HARVEST VALLEY ESTATES

Re: S/D 97-41 -- Final Plat of HARVEST VALLEY ESTATES

Re: S/D 97-41 - Revised Preliminary Plat of HARVEST VALLEY ESTATES

CASE NUMBER: S/D 97-41 HARVEST VALLEY ESTATES

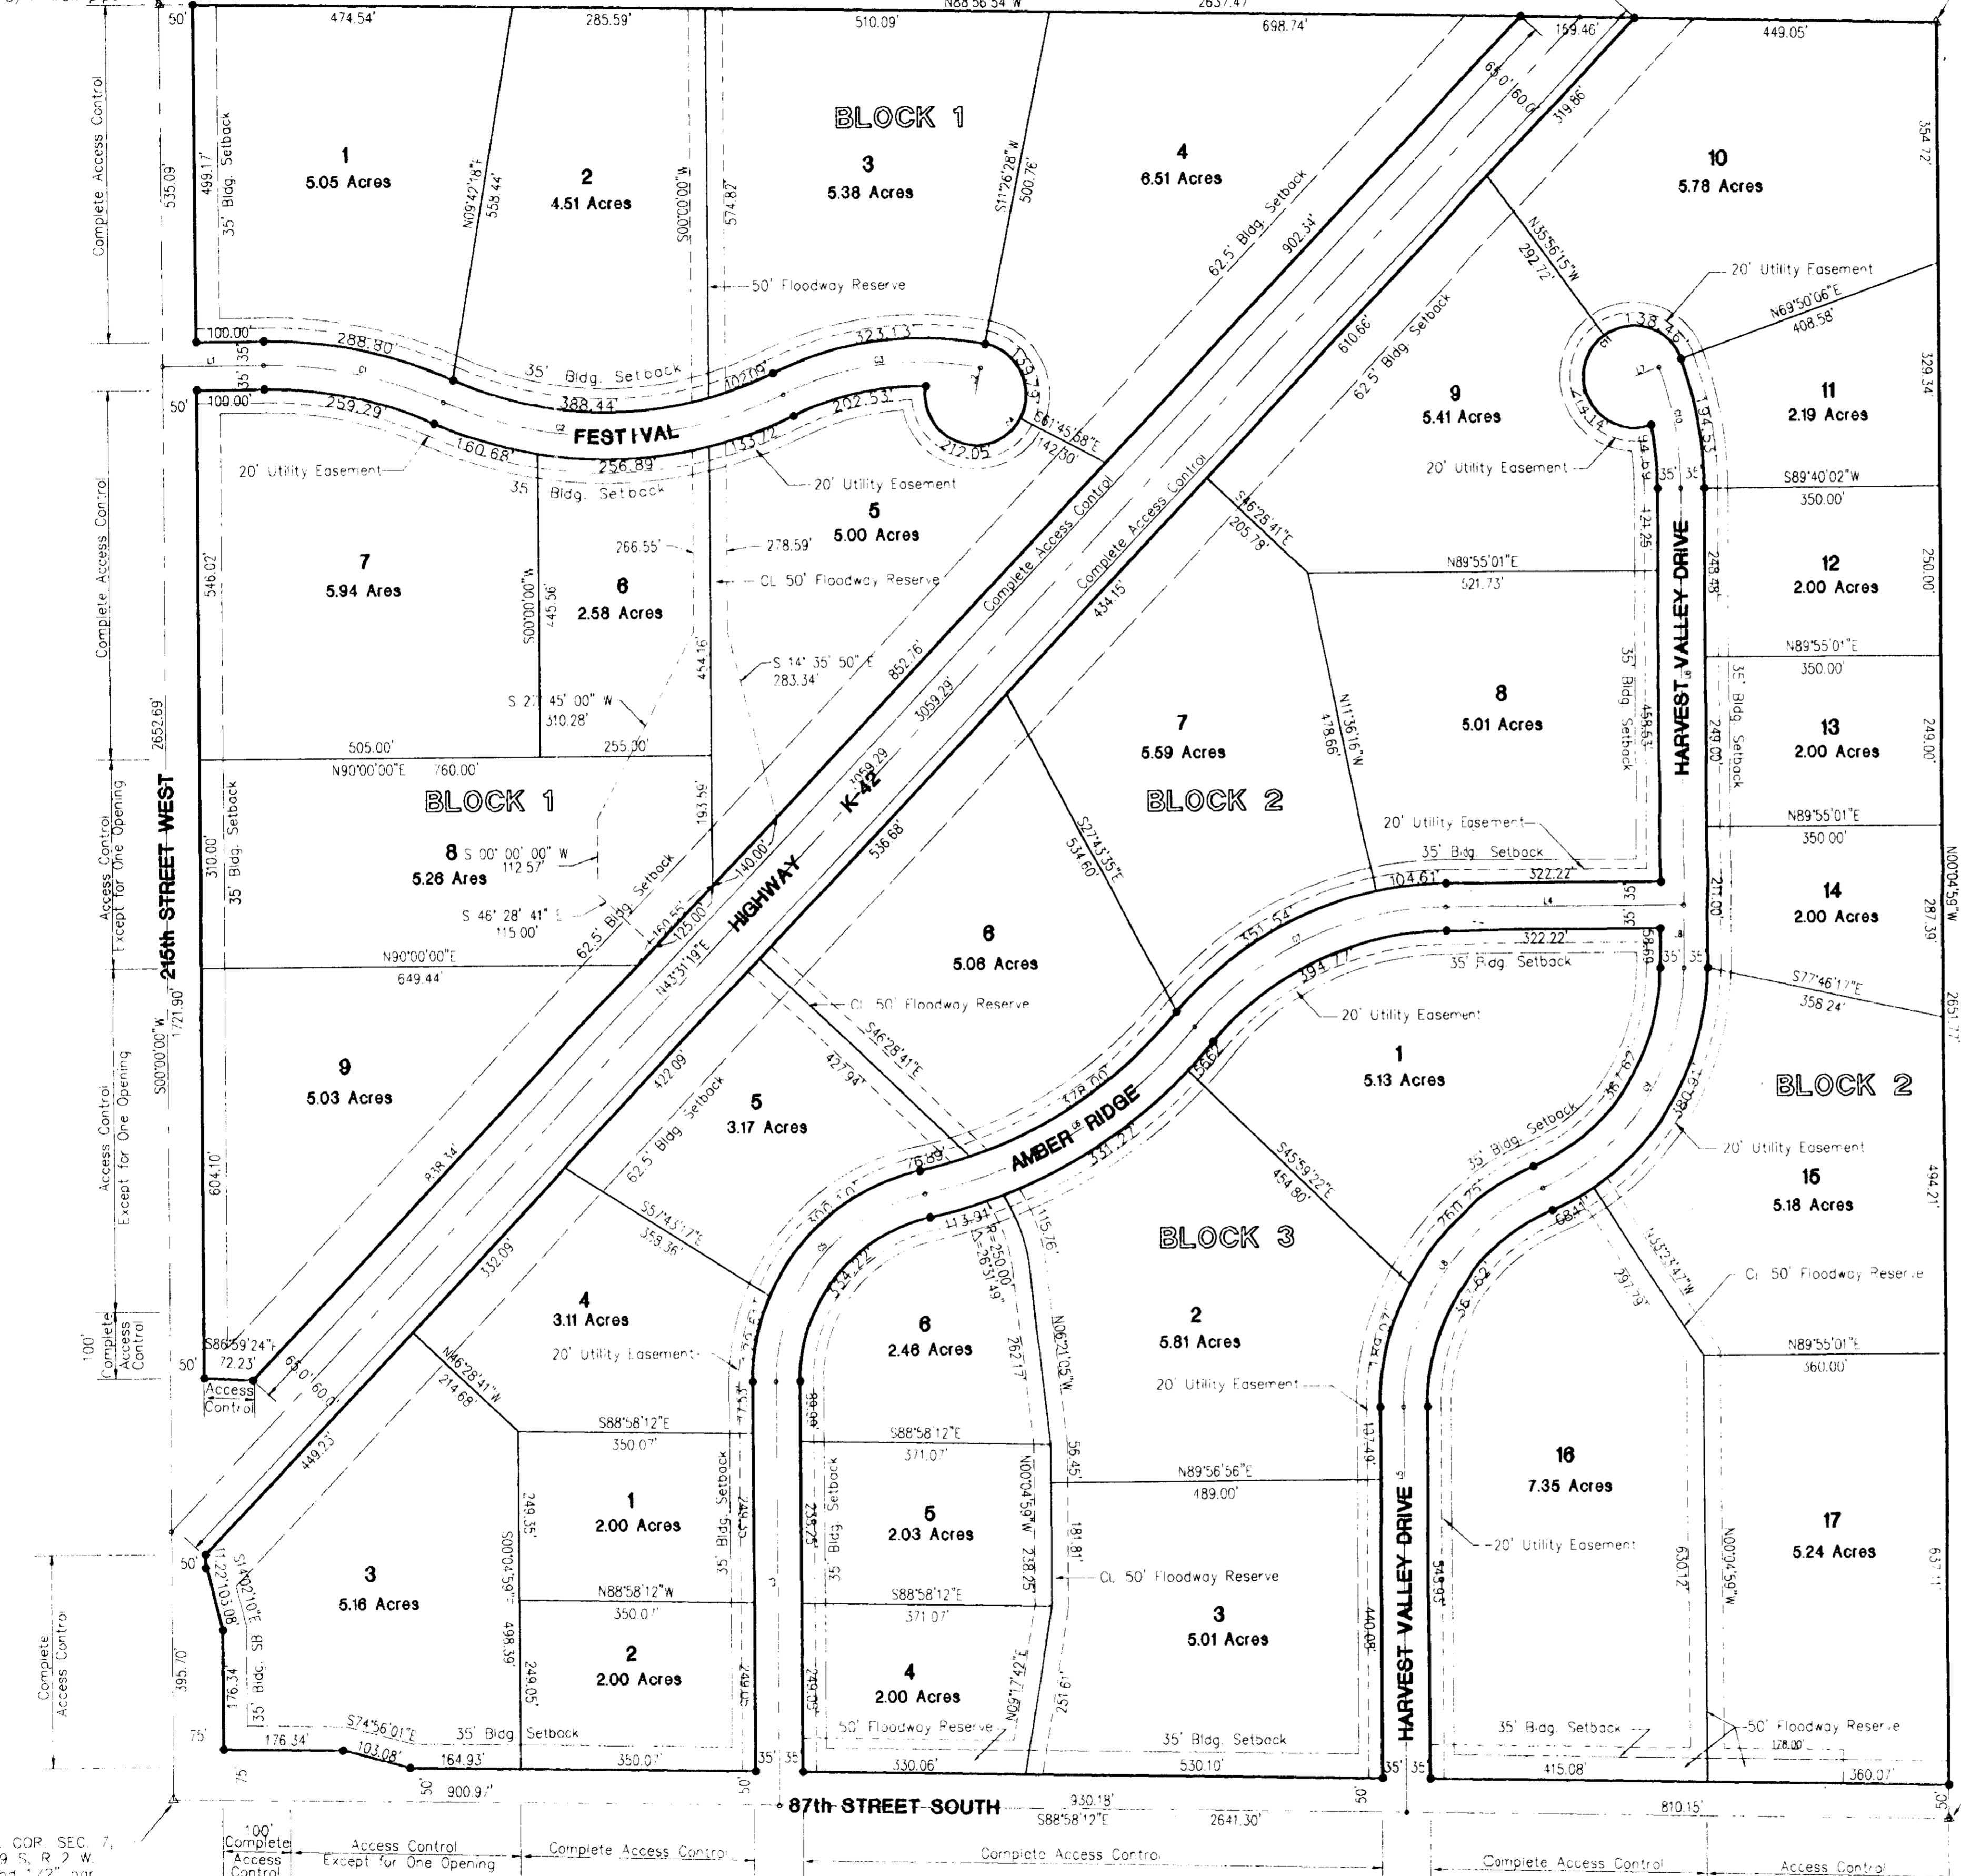
County Engineering has indicated the proposed intersections with K-42 are unacceptable. A revised street layout is needed which includes Festival Street as a cul-de-sac; a loop street combining Harvest Valley Drive, Amber Ridge and Shade Court; and a cul-de-sac replacing the current Harvest Valley Drive intersection with K-42.

The final plat includes the requested access controls. However, Lot 3, Block 2, located on the southwest corner of the plat, now denotes access to 87th Street

South, rather than 215th Street West as indicated on the preliminary plan.

County Engineering has commented that the drainage concept is acceptable. The drainage easements shall be shown on the final plat as a floodway reserve, and be a minimum width of 50 feet. The drainage easement on Lot 17, Block 2 shall be realigned to line up with the culvert under 87th Street South.

The final plat includes the requested revisions by County Engineering. On the final plat tracing, the centerline of the floodway reserves should be denoted by a dashed line. The platting text should note the creation of the Floodway reserves. County Engineering needs to comment on the status of the applicant's drainage plan. The drainage plan has been approved although revisions need to be made to minimum building pad elevations. County Engineering also requires a letter of map revision regarding the floodway located within the plat.

T. On the final plat tracing, the Chair of the MAPC should read Richard E. Lopez. The Deputy should read Michael D. Hurtt. The Chair Pro Tem should read Paul W. Hancock. Melody C. Miller should be spelled correctly.

The final plat includes a revised street layout as requested by County Engineering.
